Job Package Cover Sheet

4617263 UTL PIPE RACK SUPPORTS

Repair web and flanges of columns

REFORMER No. 3 AND
HYDROCRACKER
WEST OFFSITE PIPE RACK

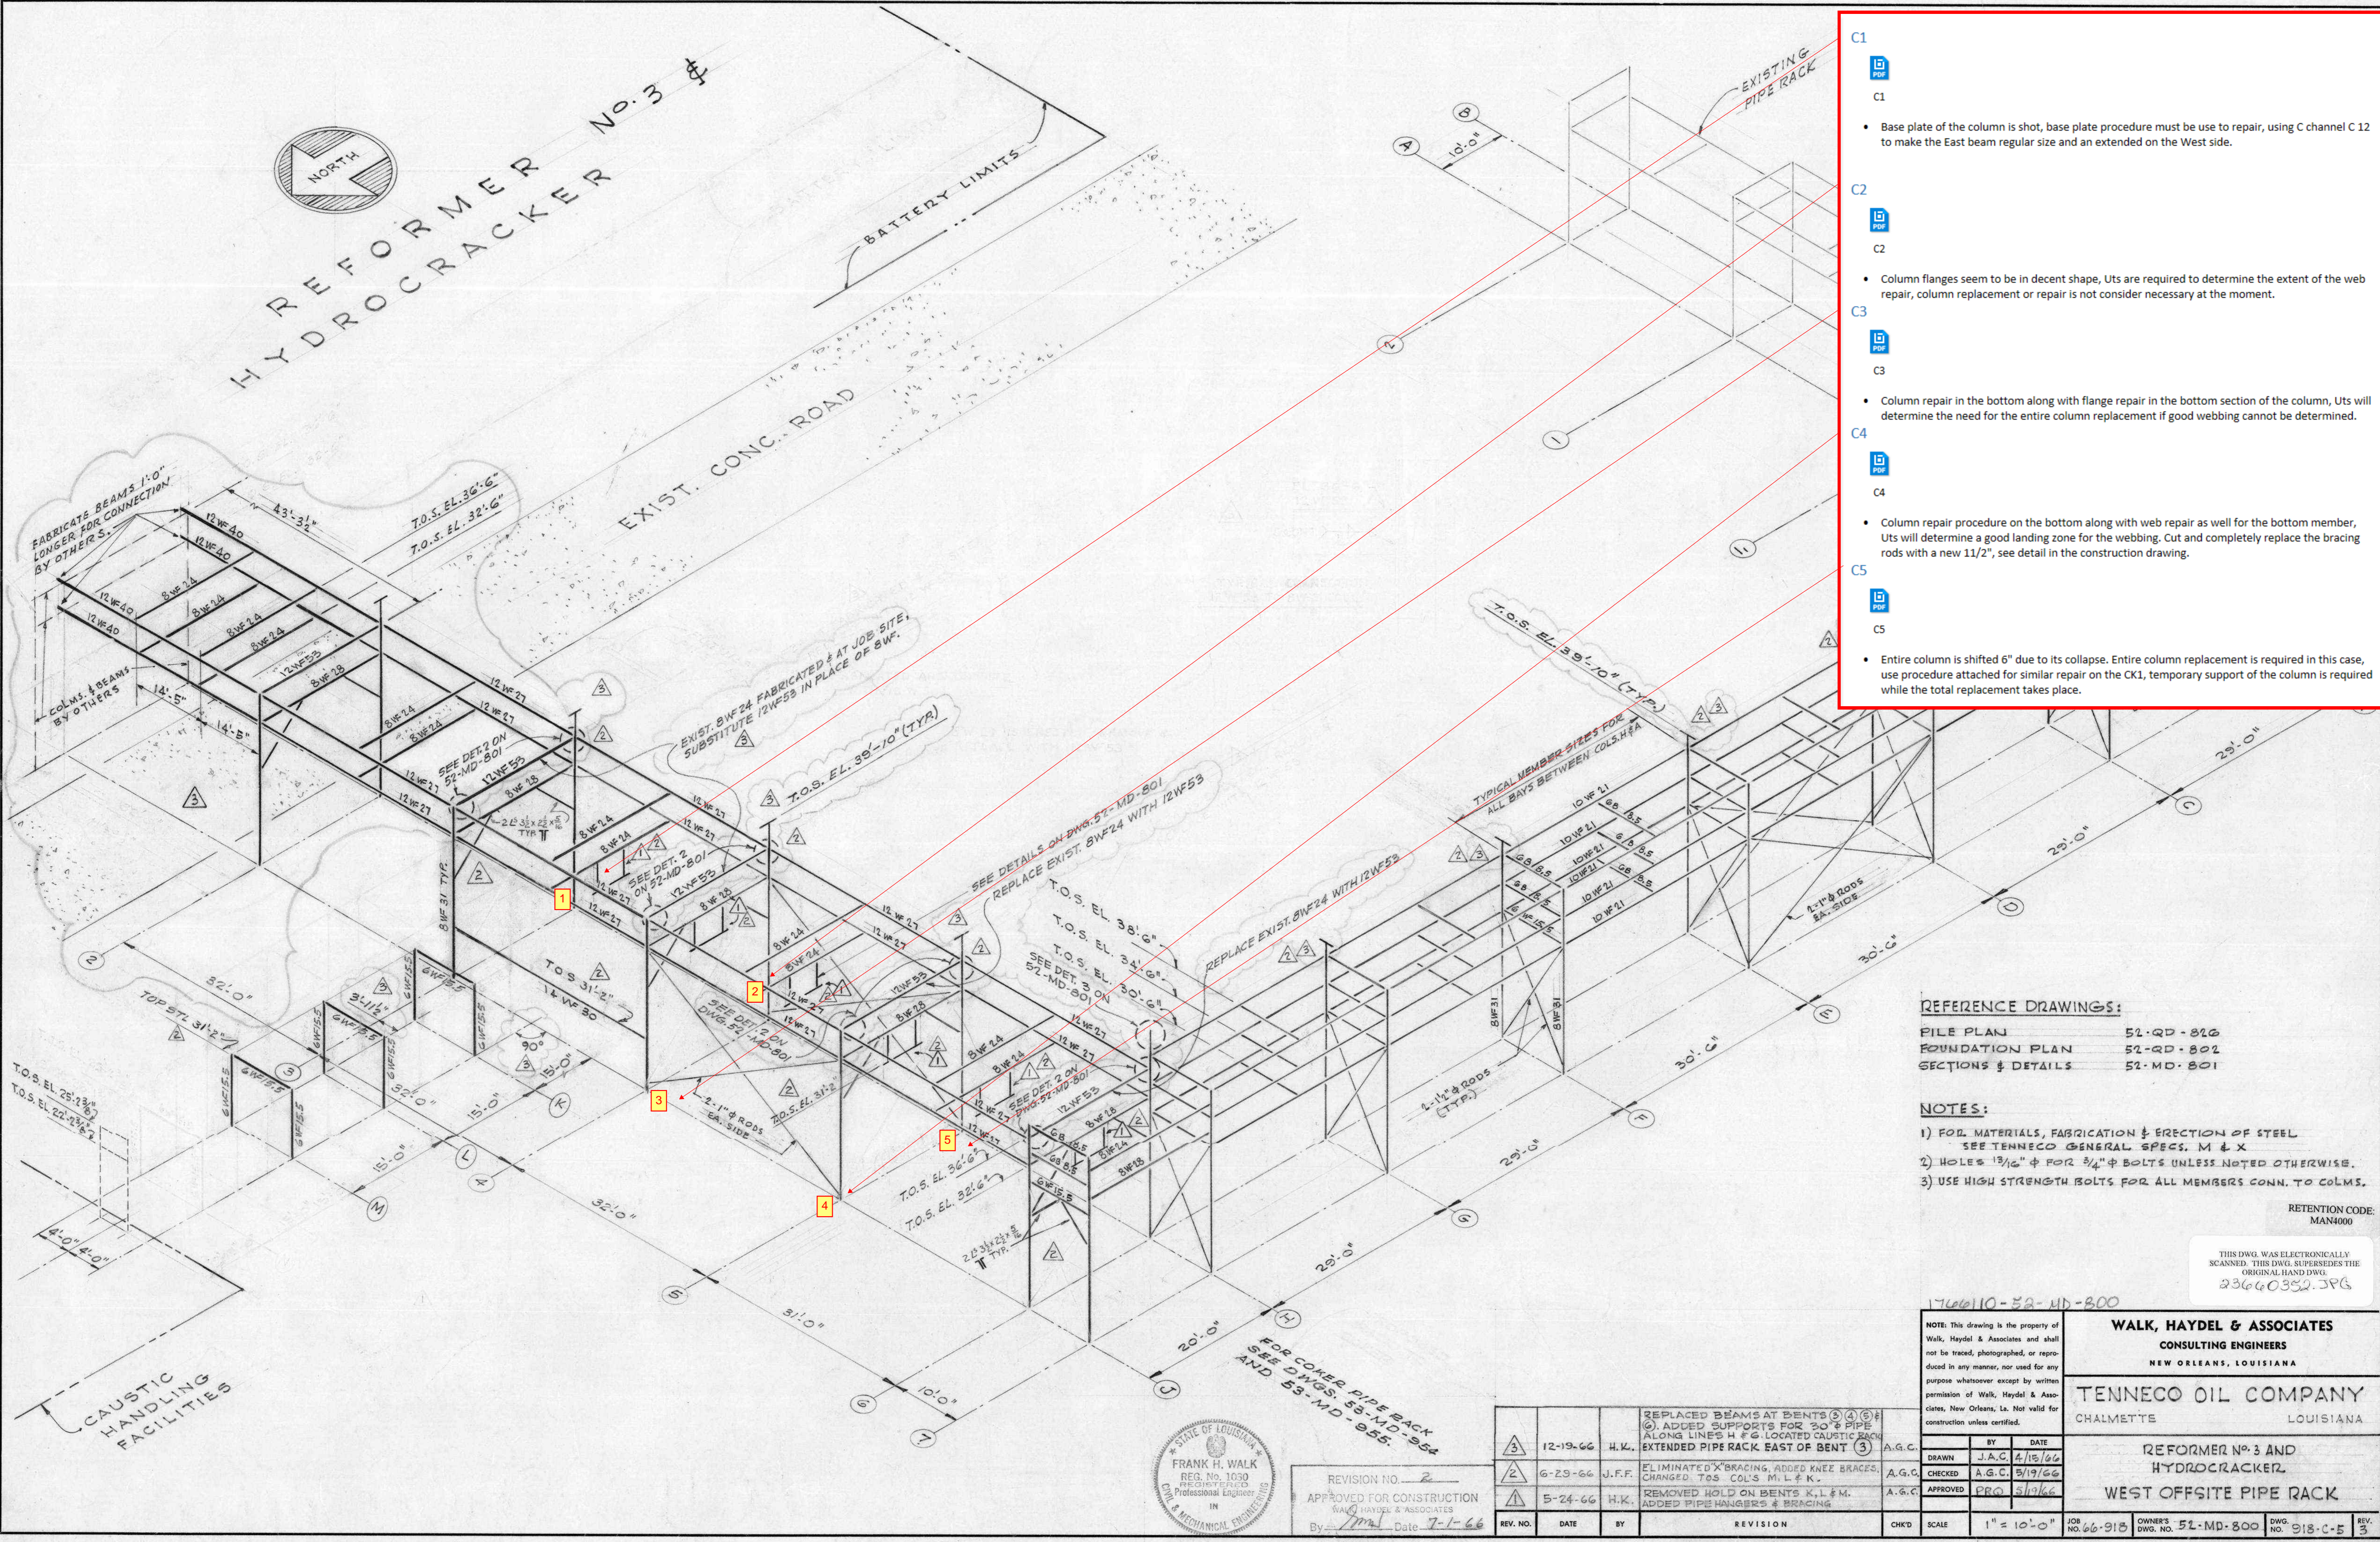
- C1**
Base plate of the column is shot, base plate procedure must be use to repair, using C channel C 12 to make the East beam regular size and an extended on the West side.

- C2**
Column flanges seem to be in decent shape, Uts are required to determine the extent of the web repair, column replacement or repair is not consider necessary at the moment.

- C3**
Column repair in the bottom along with flange repair in the bottom section of the column, Uts will determine the need for the entire column replacement if good webbing cannot be determined.

- C4**
Column repair procedure on the bottom along with web repair as well for the bottom member, Uts will determine a good landing zone for the webbing. Cut and completely replace the bracing rods with a new 1 1/2", see detail in the construction drawing.

- C5**
Entire column is shifted 6" due to its collapse. Entire column replacement is required in this case, use procedure attached for similar repair on the CK1, temporary support of the column is required while the total replacement takes place.

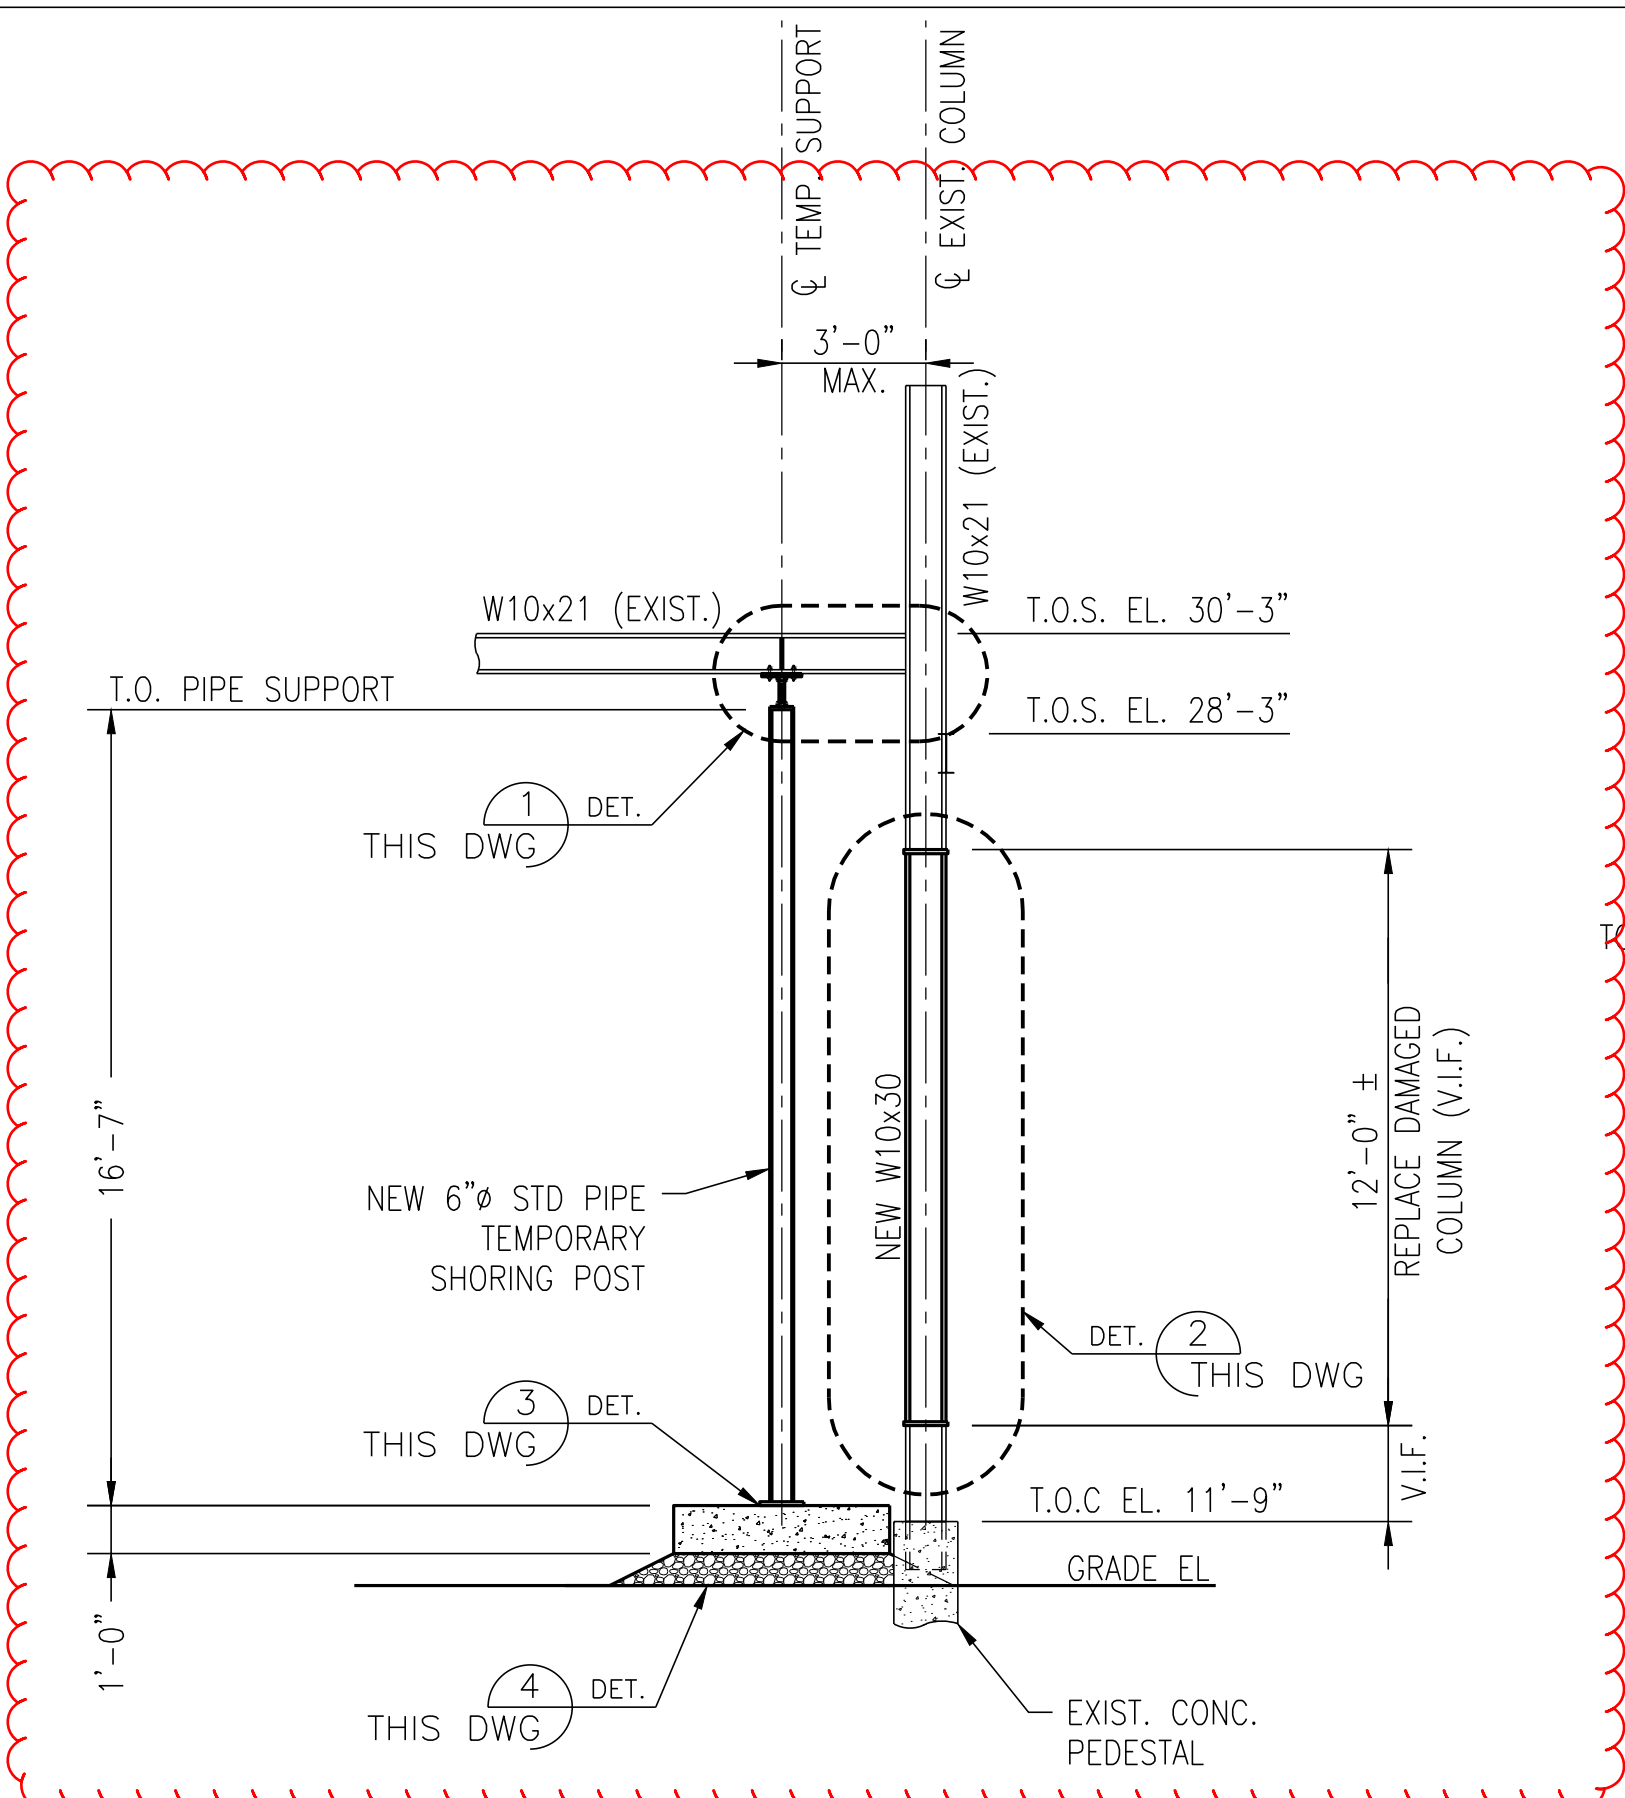
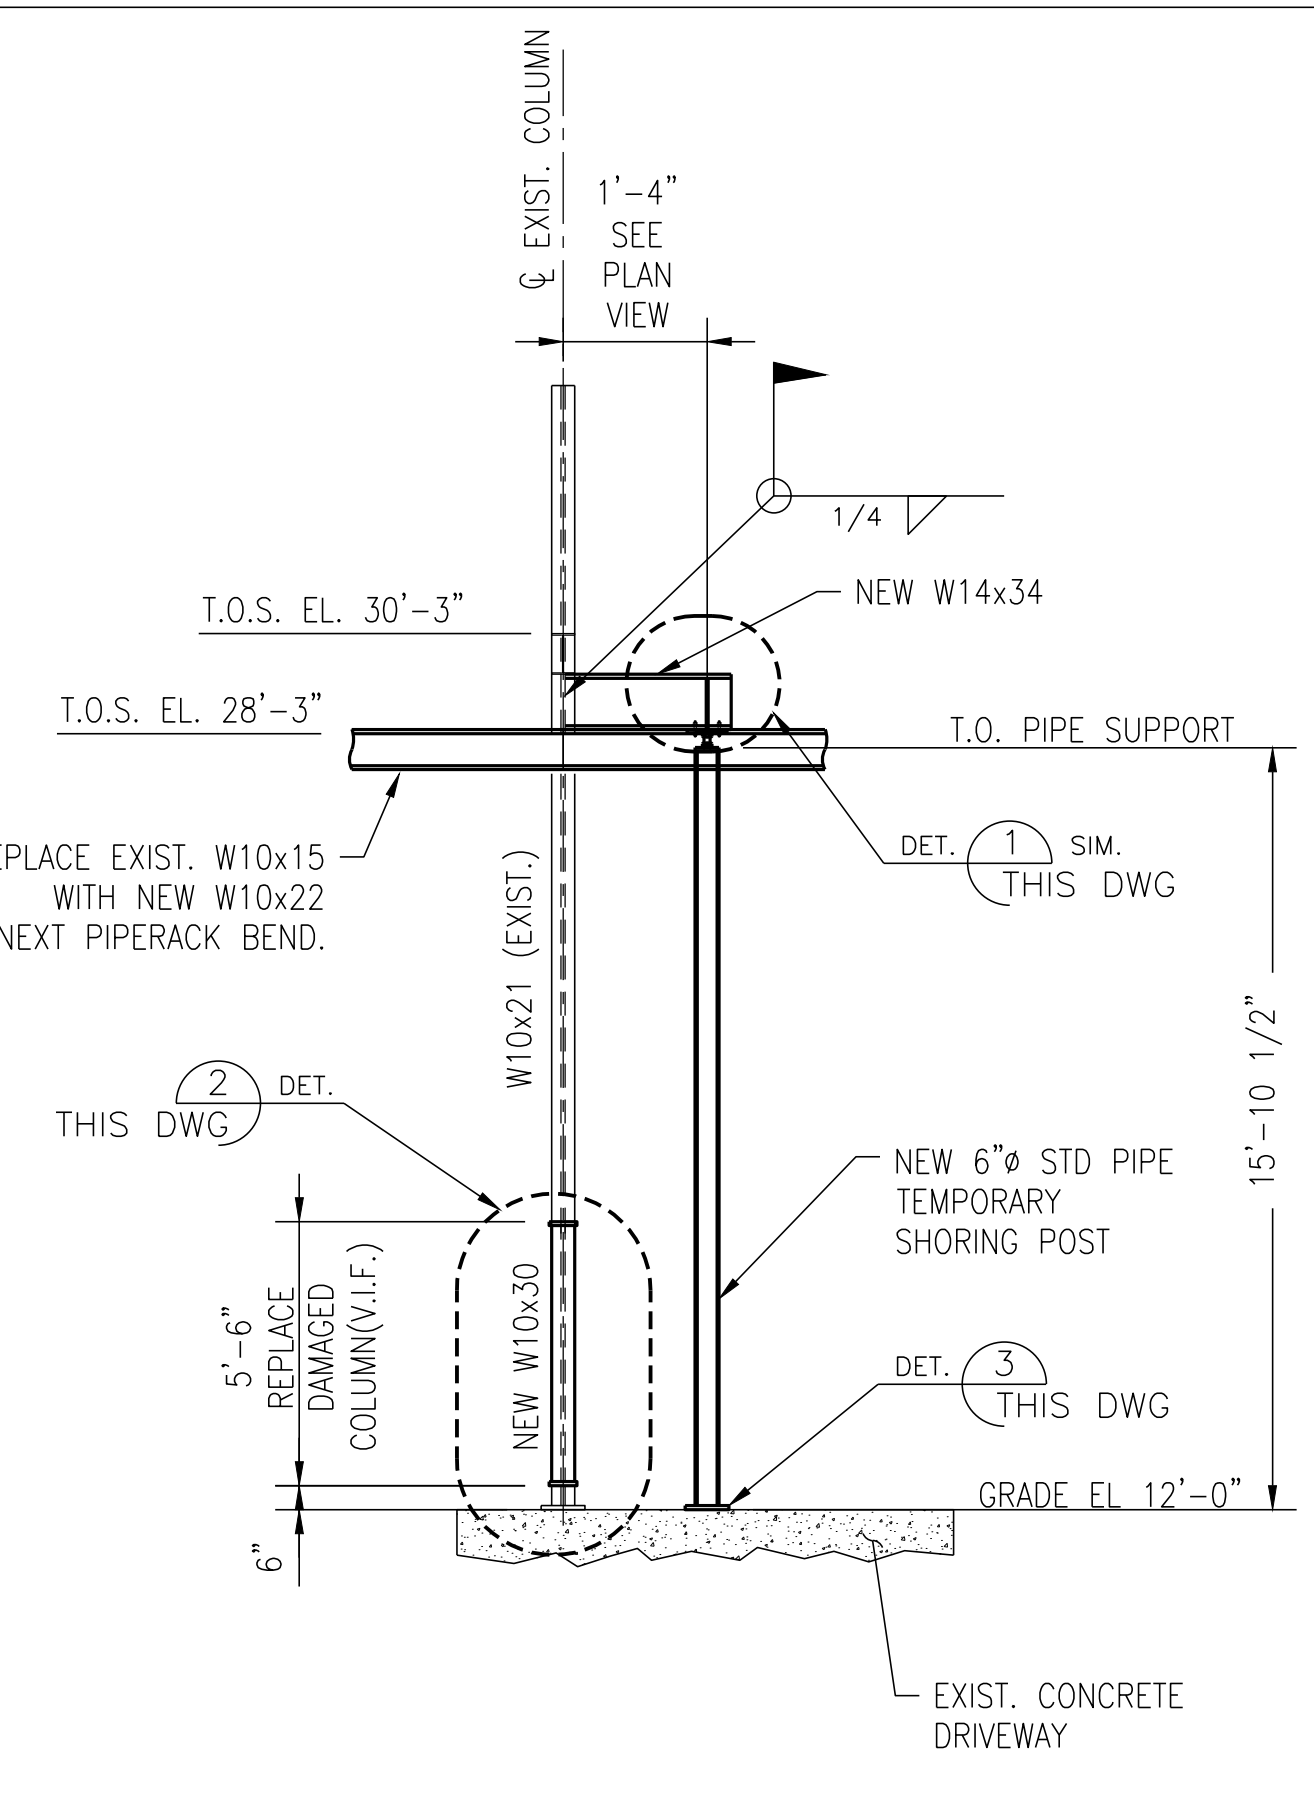
Cut and replace beam

Will require shoring to remove section of column.... use of cribbing or rock to build up

REPLACE COLUMN AND BASE PLATE
